Form 3160-5 (June 2019)

1. Type of Well						
Oil Well Gas W	_		8	. Well Name and No.	NELLIS FEDERAL/06	
2. Name of Operator LEGACY RESER	RVES OPERATING LP		9	API Well No. 3002	2531608	
3a. Address 15 SMITH ROAD SUITE	3000, MIDLAND, TX 79	3b. Phone No. (include area code	e) 1	10. Field and Pool or Exploratory Area		
	,	(432) 689-5200	I .	BUFFALO VALLE	Y/BUFFALO VALLEY

Field/Pool
 Buffalo Yates
 API #:
 30-025-31608

Operator:	OGRID:
LEGACY RESERVES OPERATING, LP	240974
15 Smith Road	Action Number:
Midland, TX 79705	169513
	Action Type:
	[C-103] NOI Plug & Abandon (C-103F)

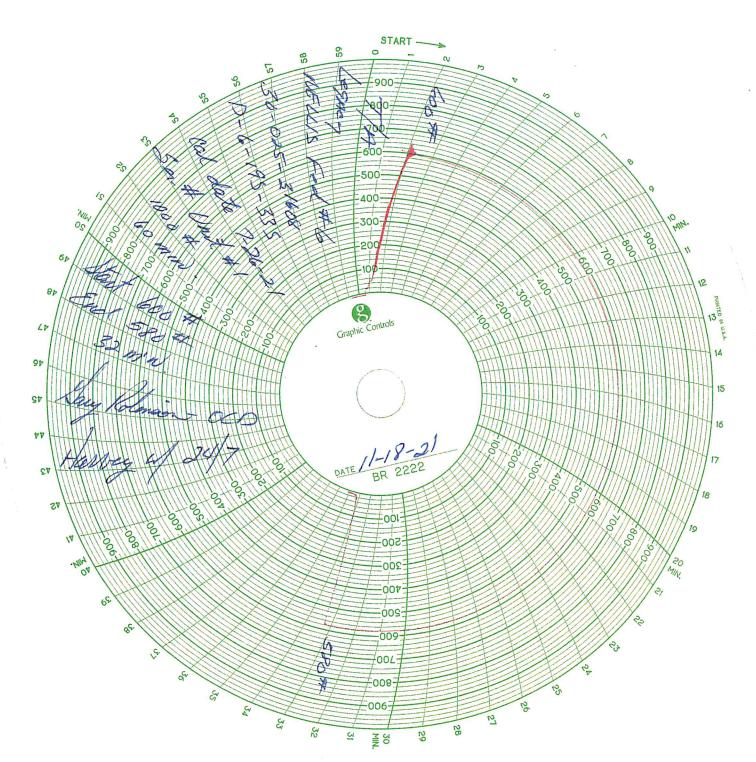
- 1. Previous TA. Last MIT 11/18/21.
- 2. RIH & tag TOC @ 3418'. Record tag depth. Contact BLM Field Rep if lower than noted.
- 3. Spot 38 sx cmt @ 3165'-2850'. (Yates/Transil-B/Salt). Tag and verify
- 4. Spot 25 sx cmt @ 1560'-1444'. (Rustler- T/salt). Tag and verify
- 5. Perf & Sqz 55 sx cmt @ 475'-Surface. 8-5/8" Shoe & Surface plug. Contact field rep if no rate @ shoe.
- 6. Cut off well head, verify cmt at surface, weld on dry hole marker.

1444'. Adj. for excess 10%/1000'. Tag and verify

2850'. Adj. for excess 10%/1000'. Tag and verify Transil B Salt @ 2930'

Plug Type	Тор	Bottom	Length	Tag	Sacks	Notes
				circulated		
Surface Plug	0.00	475.00	475.00	to surface	55.00	
				WOC and		
Shoe Plug	370.75	475.00	104.25	Tag	55.00	
				WOC and		
Top of Salt @ 1510	1444.90	1560.00	115.10	Tag	25.00	
Base of Salt @ 2930	2850.70	2980.00	129.30	WOC and	38.00	Same as below plug
				WOC and		
Yates @ 3115	3033.85	3165.00	131.15	Tag	38.00	
				WOC and		
CIBP Plug	3419.00	3454.00	35.00	Tag
